Contract HK 12/02
Central Reclamation Phase III – Engineering Works
Environmental Permit No.: FEP- 01/122/2003

**Certification and Verification for Change of FEP Condition 3.2 –
Concurrent Dredging/ Filing at FRAW & FRAE**

ET Leader's Certification

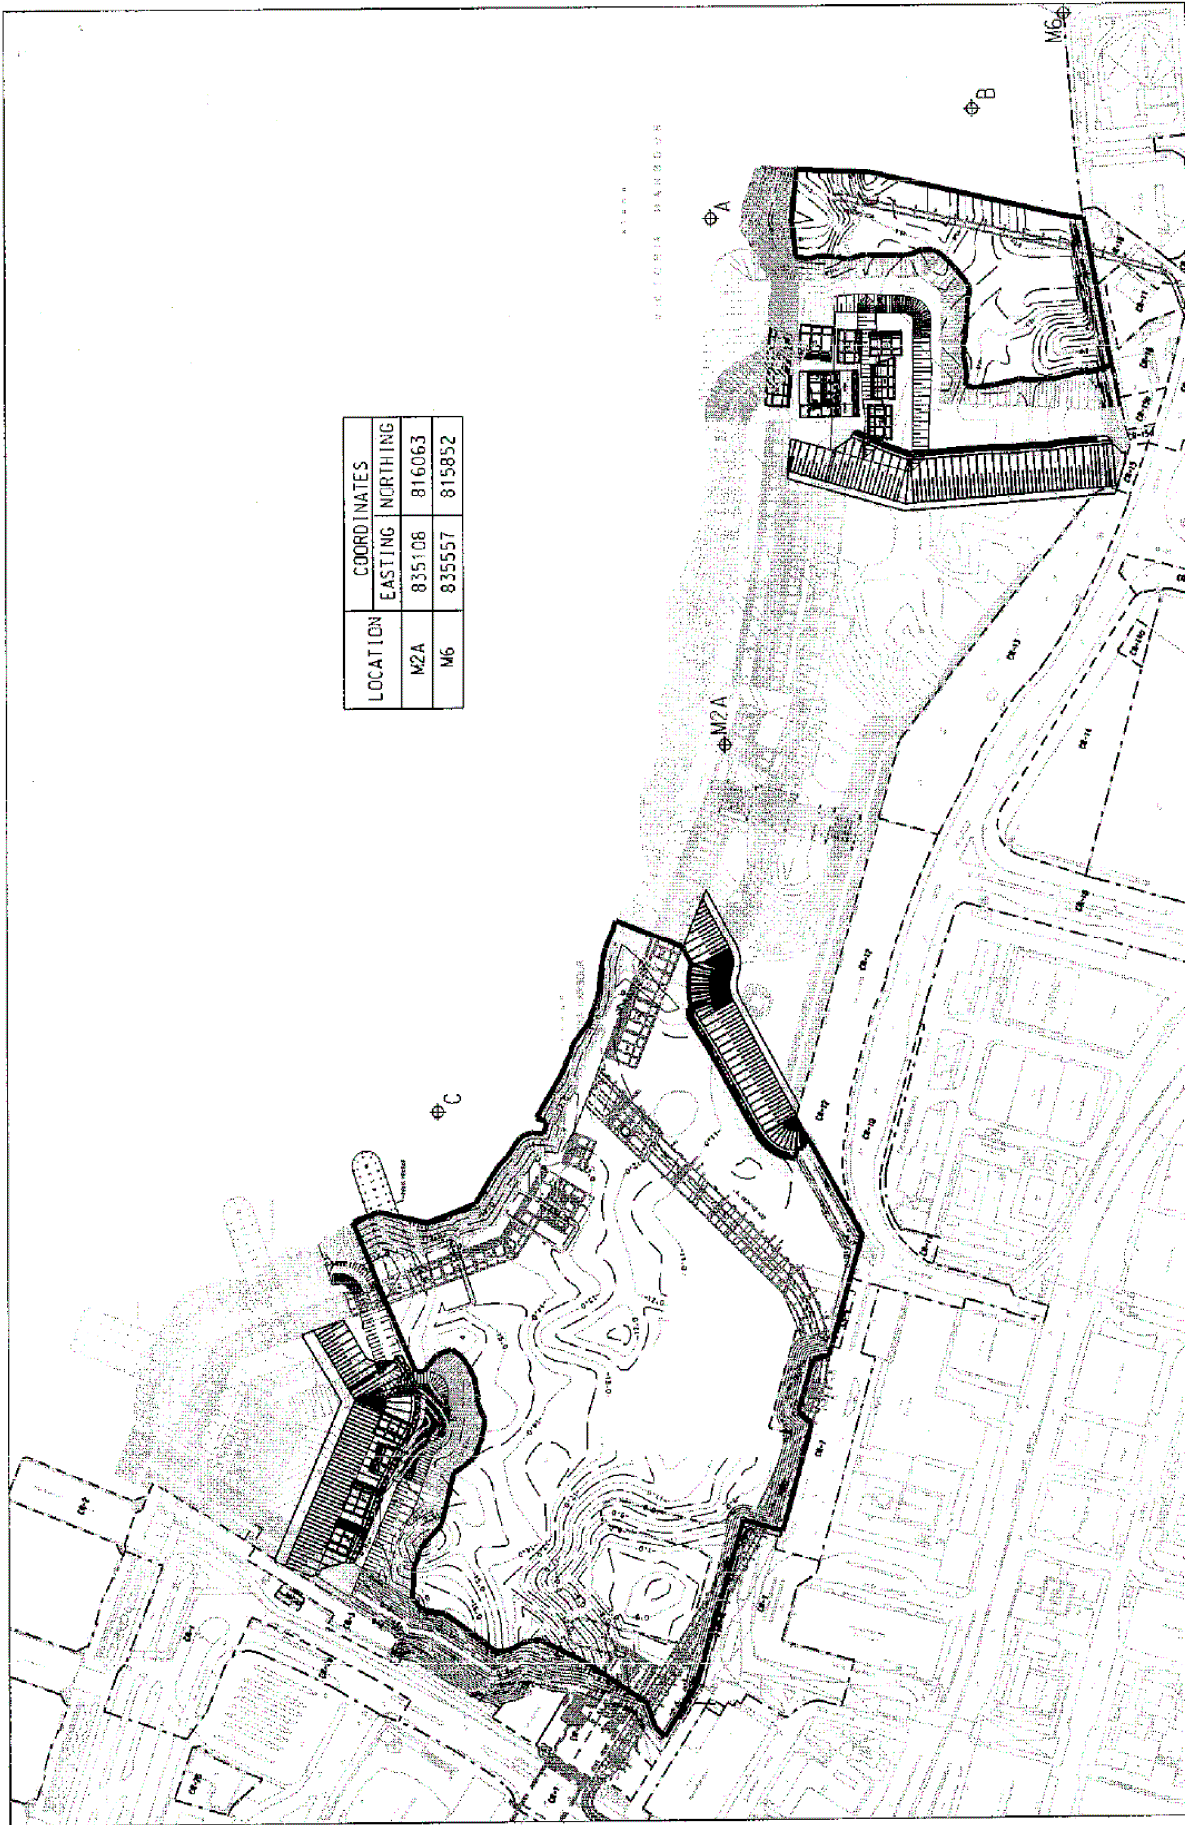
(2) The JV shall undertake additional water quality at 3 additional (mobile) monitoring stations (i.e. A, B & C) within 50m of the immediate area of the dredging works (A and C being to the North of the dredger at FRAE and FRAW respectively, while B being in between the dredger operating at FRAE and M6) shall be undertaken immediately after completion of dredging works each day.

At each mobile station, water samples shall be collected in duplicate at 3 depths, viz. 1m below surface, mid depth and 1m above seabed, except where the water depth is less than 6m, the mid depth shall be omitted. Should the water depth is less than 3m, only the mid-depth is required.

(3) During this period, should there be any exceedance of the Action Level in 2 consecutive occasions or exceedance of the Limit Level in one occasion for the SS in the water samples at any of the seawater intakes (including but not limit to M6, M4B and M2A), dredging rate at FRAE and FRAW should be reduced to the original rates of 98m³/h and 184 m³/h respectively prescribed in the FEP and possible cessation of works.
